Responses to Request for Additional Information – Supplemented August 2, 2021
Certificate of Compliance No. 1032
Docket No. 72-1032
HI-STORM FW Storage System
Amendment No. 6

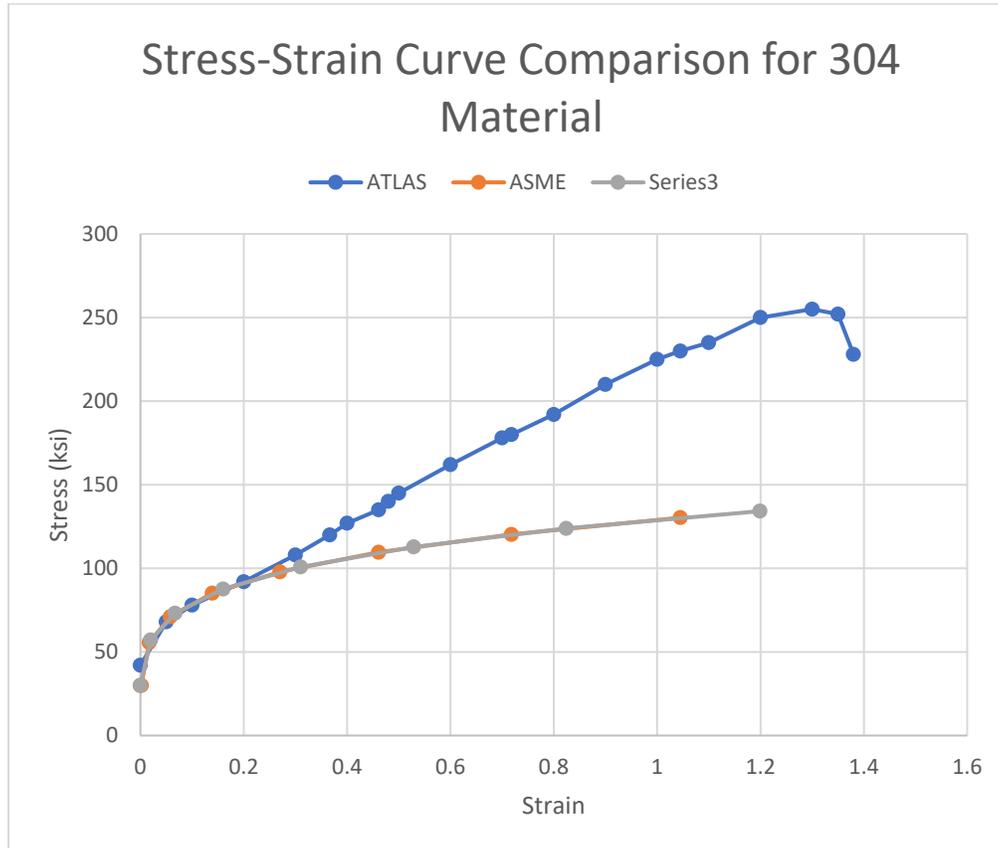
- a) mechanical property data based on physical testing for the materials evaluated using a strain-based approach for the drop accident conditions presented in Holtec Report HI-2200647;
- b) failure strains and material flow curves based on this physical testing that consider strain-rate effects, uniform elongation, and triaxiality effects for use in the finite element analysis and structural evaluation of the drop accident conditions presented in Holtec Report HI-2200647; and
- c) an updated finite element analysis and structural evaluation of the drop accident conditions presented in Holtec Report HI-2200647 using failure strains and material flow curves based on mechanical property data obtained from physical testing.

As the mechanical property data is essential to the validity of the structural analysis of the drop accident condition, the staff requests that the material models used in the LS-DYNA simulations described in Holtec Report HI-2200647 be based on sufficient physical testing and any results be updated.

The following figure show the comparison between the material flow curves for a typical stainless-steel 304 material using 2 distinct approaches, as follows:

It is clearly noted that the curve developed using the ASME minimum properties, which is the basis for the licensing analysis in support of this amendment, is lower than the curve obtained from the other two sources.
